**15-DAY EXPRESS TERMS
FOR
PROPOSED BUILDING STANDARDS
OF THE
DIVISION OF THE STATE ARCHITECT (DSA-AC)

2013 CALIFORNIA BUILDING CODE
INTERVENING CODE CYCLE**

**CHAPTER 11B
ACCESSIBILITY TO PUBLIC BUILDINGS,
PUBLIC ACCOMMODATIONS, COMMERCIAL BUILDINGS AND PUBLIC HOUSING**

Figure 11B-411.2.1.2.3
Destination-Oriented Elevator Accessibility Function Button Indication

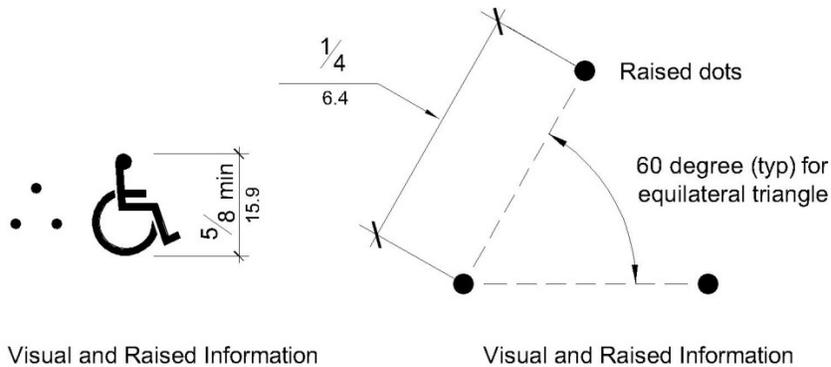
11B-411.2.1.2.3 Accessibility function button. The accessibility function button shall be identified by the International Symbol of Accessibility and a raised indication. The International Symbol of Accessibility shall comply with Section 11B-703.7.2.1, and shall be 5/8 inch (15.9 mm) minimum in height. The indication shall be three raised dots. Each dot shall have a base diameter of 0.59 inch (1.5 mm) minimum and 0.063 inch (1.6 mm) maximum and a height of 0.025 inch (0.6 mm) minimum and 0.037 inch (0.9 mm) maximum. The dots shall be spaced 1/4 inch (6.4 mm), measured center to center, in the form of an equilateral triangle with a vertex pointing up. The accessibility function button shall not be provided with a key repeat function.

Figure 11B-411.2.3
Floor Designation and Car Designation Signs on Jambs
of Destination-Oriented Elevator Hoistway Signs

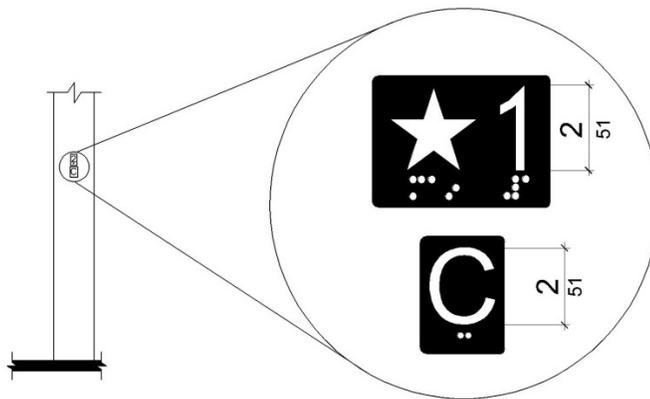
11B-411.2.3.1 Floor designation signs. Floor designation signs complying with Sections 11B-703.2 and 11B-703.4.1 shall be provided on both jambs of elevator hoistway entrances. Signs shall be provided in both raised characters and Braille. Raised characters shall be 2 inches (51 mm) high. A raised star placed to the left of the floor designation, shall be provided on both jambs at the main entry level. The outside diameter of the star shall be 2 inches (51 mm) and all points shall be of equal length. Raised characters, including the star, shall be white on a black background. Braille complying with Section 11B-703.3 shall be placed below the corresponding raised characters and the star. The Braille translation for the star shall be "MAIN". Applied plates are acceptable if they are permanently fixed to the jamb.

11B-411.2.3.2 Car designation signs. Car designation signs complying with Sections 11B-703.2 and 11B-703.4.1 shall be provided on both jambs of the hoistway immediately below the floor designation. Signs shall be provided in both raised characters and Braille. Raised characters shall be 2 inches (51 mm) high. Raised characters shall be white on a black background. Braille complying with Section 11B-703.3 shall be placed below the corresponding raised characters. Applied plates are acceptable if they are permanently fixed to the jamb.
